TO: License Fee Management Branch
FROM: Region III
SUBJECT: VOIDED APPLICATION

Control Number: 89649
Applicant: Harris Semiconductor
Date Voided: 2-27-91

Subject: Control Number 89649 - Supplementary Information

Subject: Response to Commission Letter dated 12/3/90 - Control
Number 89649

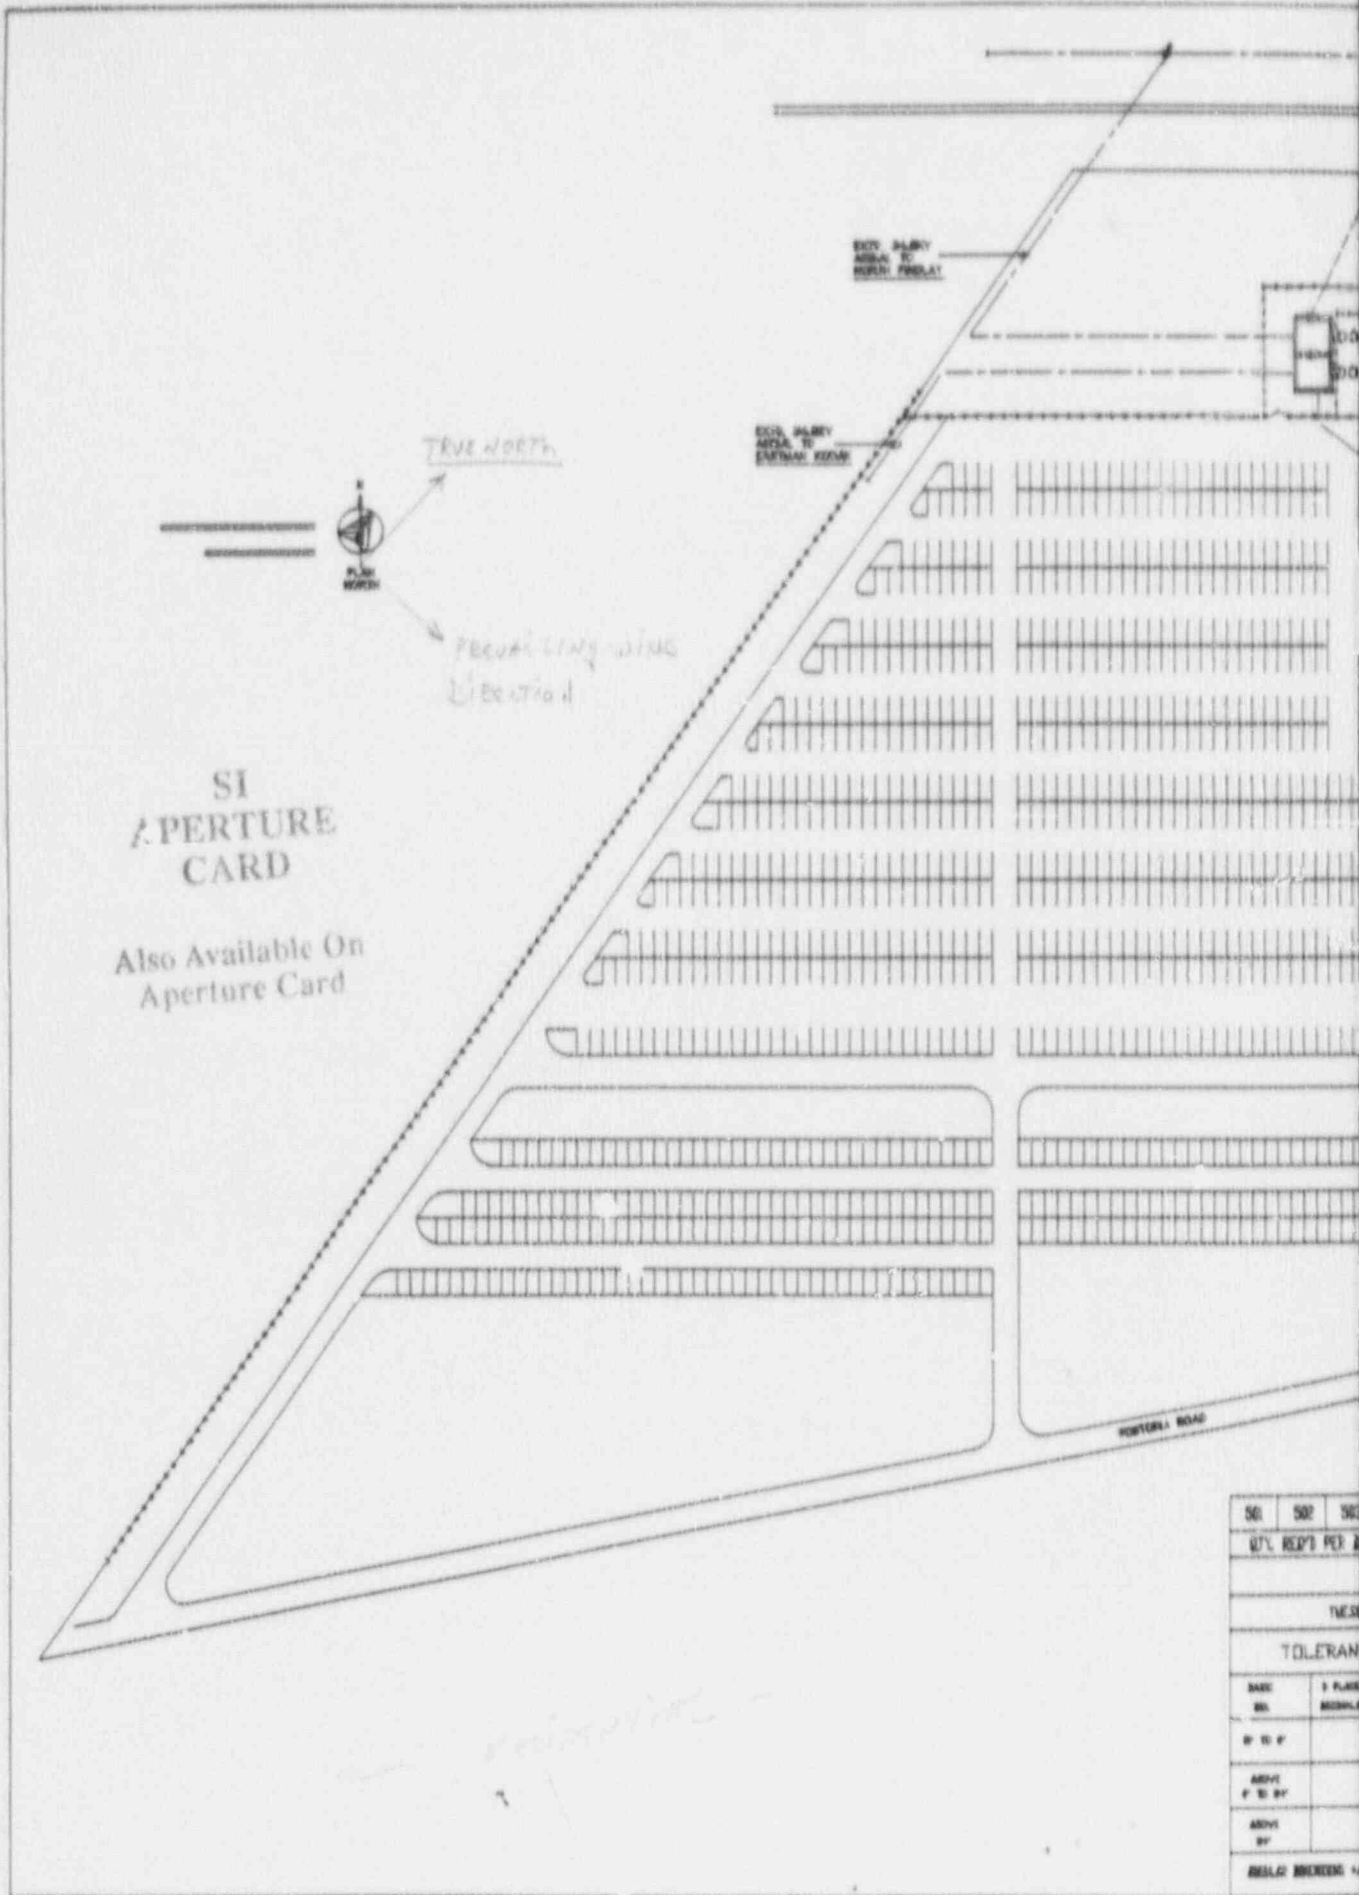
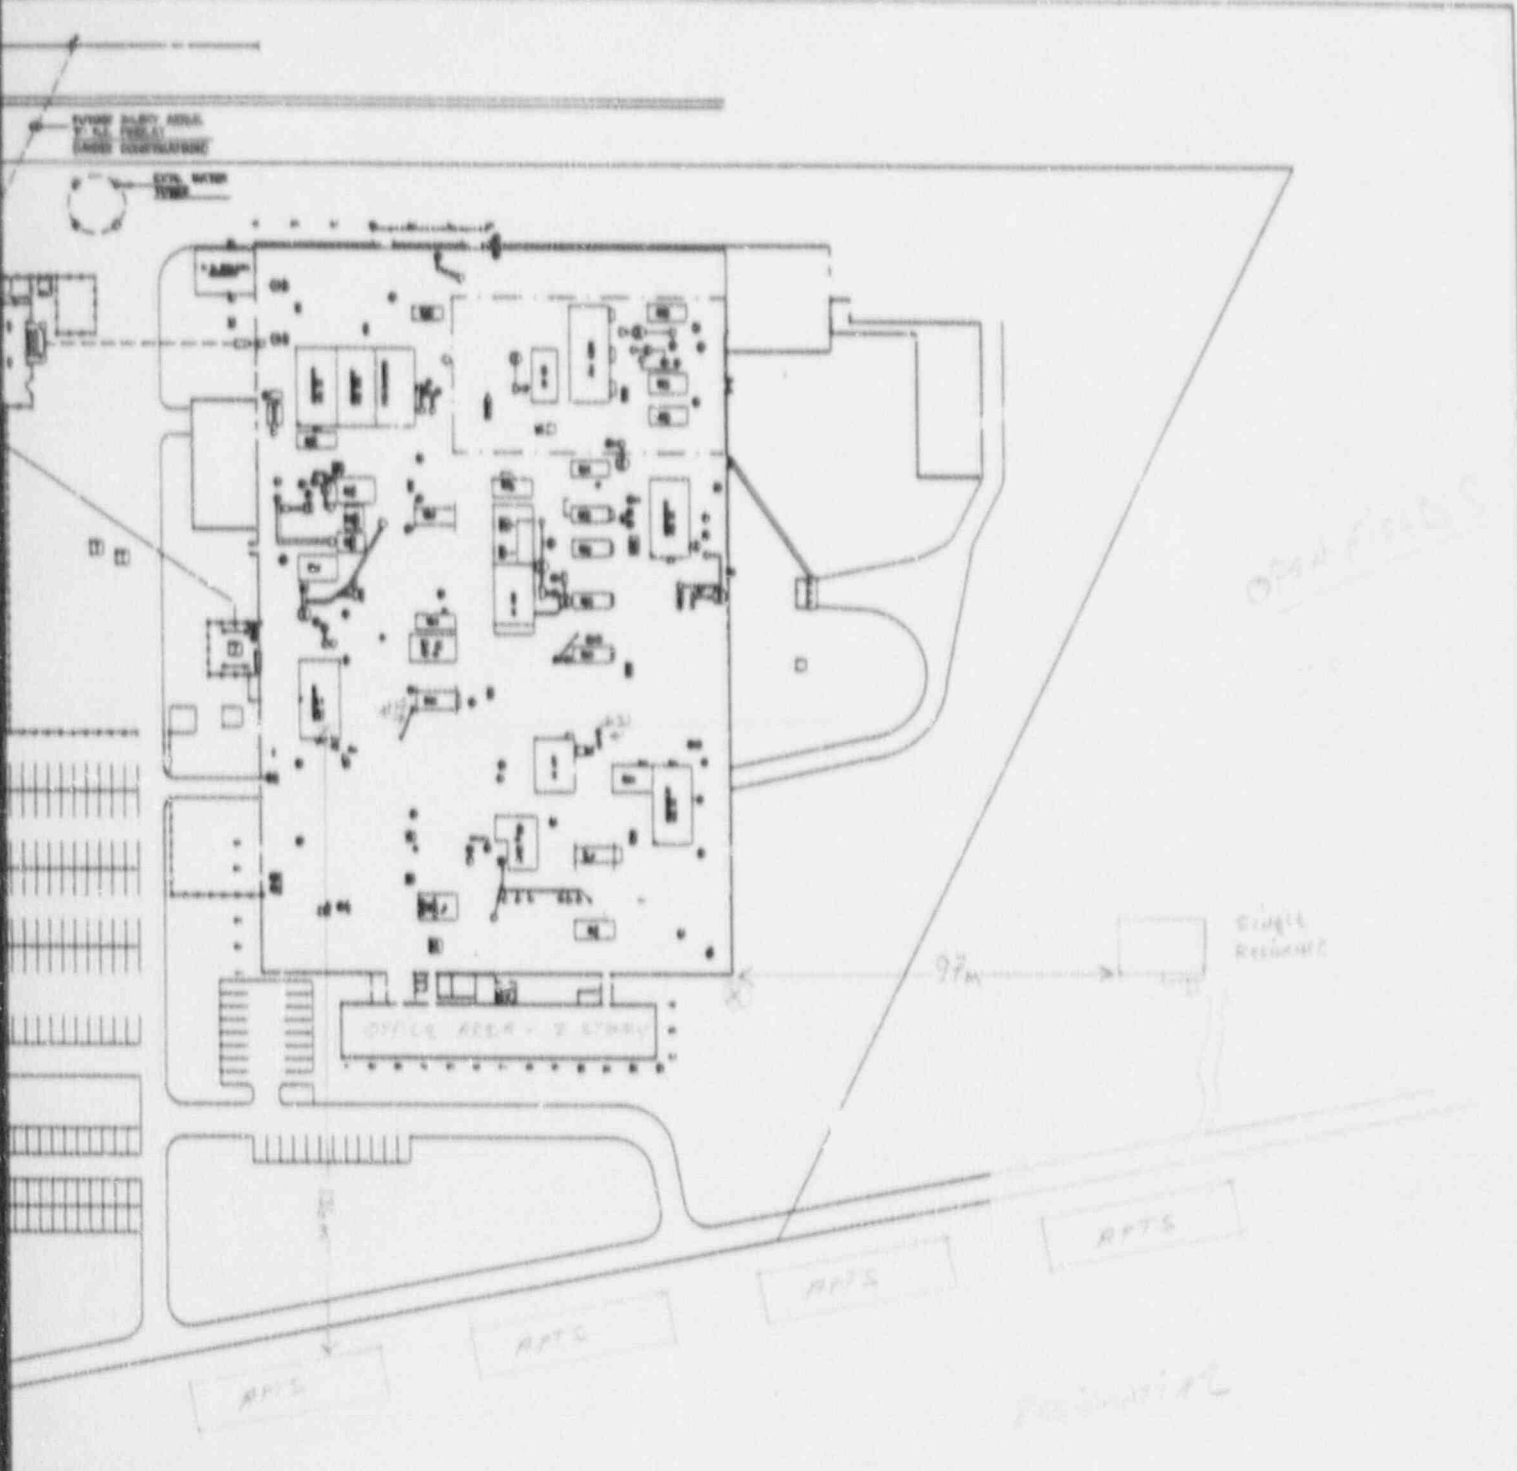
2. In order to evaluate the release, please provide for each system the following information:
 - a. Diagram of the system including storage tank, piping, isolation and flow control valves, monitoring devices including stack monitoring, etc. (If any modification of system is required please identify it in the diagram and provide a separate detailed description.)

- c. Identify for each stack the distance to the current nearest air intake and the nearest offsite building and its use, and provide an evaluation of air concentrations at these locations based on planned releases.

7. A roof map is attached showing stack and air handler locations. The safe wind direction area is also shown. Venting will be terminated if the wind velocity is less than 5 mph or the direction shifts outside the safe wind direction area.

- 2c. The Mark V unit is exhausted via stack #17 and the Minirad unit is exhausted by stack #31. The nearest air handler with an air intake (#7) is 15 meters down wind in the prevailing wind direction. An estimation of the air concentration at this location is not necessary since this air intake will be blocked off with polyethylene sheet and the air handler set to full return air before any venting of diluted gas occurs.

- 2e. The wind vector can vary between 0 and 130 degrees from true north without the other air handler intakes becoming an issue. Fortunately, the prevailing wind direction lies well within this arc. Wind speed should be relatively constant with minimal inversion. If mentioned conditions cannot be achieved, the venting will not be initiated.
